KILDARE COUNTY COUNCIL

PLANNING REPORT

Planning Ref. No.:2561294

Name of Applicant	Ricky Wilson
Address of Development	Straffan Road, Alasty, Co. Kildare.
Type of Permission	Permission & Retention
Application Date	14/11/2025
Date Inspected	12/01/2025
Due Date	17/01/2025
Site Size	0.510ha
Proposed Development	The development consists of retention permission for. • Retention of road widening works at the site entrance along the Straffan Road (L-2007). The development consists of planning permission for. • Reinstatement of blockwork piers and entrance gates with specialist fabricator to extend gate length to fit c.4.8m wide opening. • Change of use of redundant farm steadings/dwelling buildings from agricultural/residential use to guesthouse. • Renovation/restoration of redundant farm buildings including reroofing. • Extension/amalgamation of 2 no. buildings (c.176 sq. m - extension area) • Demolition of 5 no. external stores/out houses (c.309 sq. m total). • Provision of 4 no. outdoor patio spaces. • Roof Mounted PV panels (c.31 sq. m)

Figure 3: Proposed Soft Landscaping Plan

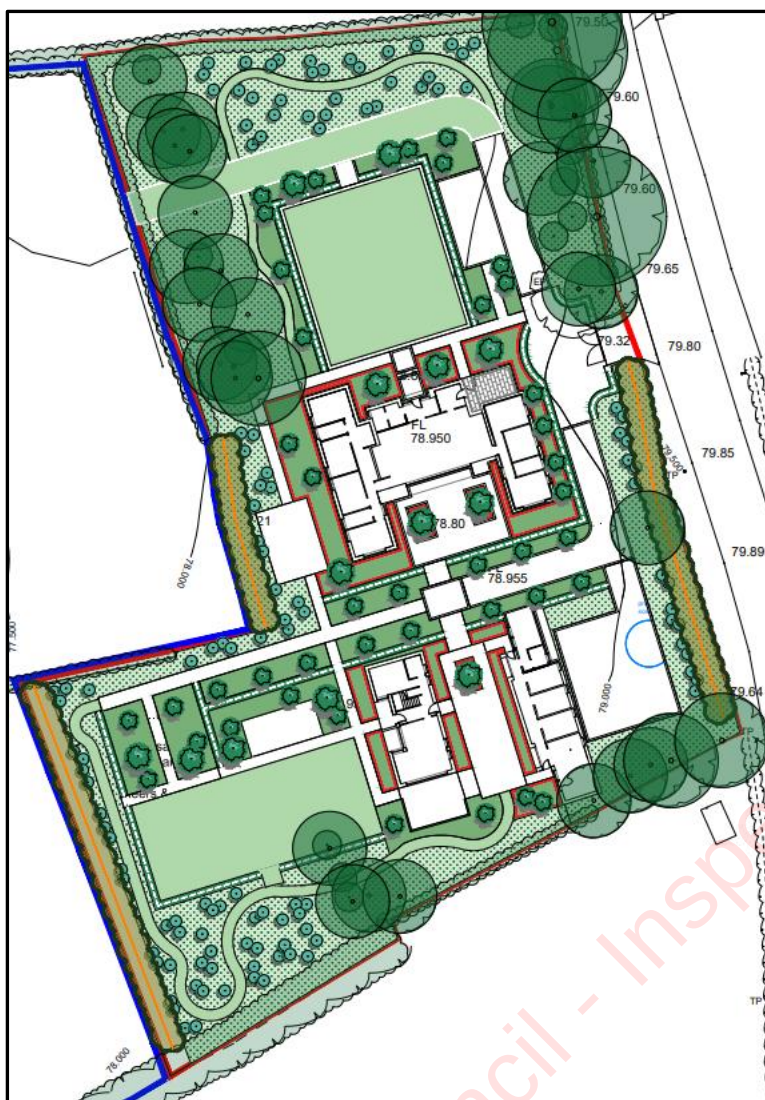
1. In figure 3 (below) there is a grass cut pathway right at the northern boundary of the site, which is adjacent to a neighbouring house. This area should be left as a buffer zone to maintain privacy between the proposed development and the neighbouring dwelling to the north. The Applicant will be requested to submit a revised Landscaping Plan to include a 10m buffer zone without any pedestrian paths along the northern boundary of the site.

- a. There is a grass cut pathway right at the northern boundary of the site, which is adjacent to a neighbouring house. This area should be left as a buffer zone in order to maintain privacy between the proposed development and the neighbouring dwelling to the north. The Applicant is requested to submit a revised Landscaping Plan to include a **10m planted buffer zone** along the northern boundary of the site without any pedestrian paths.
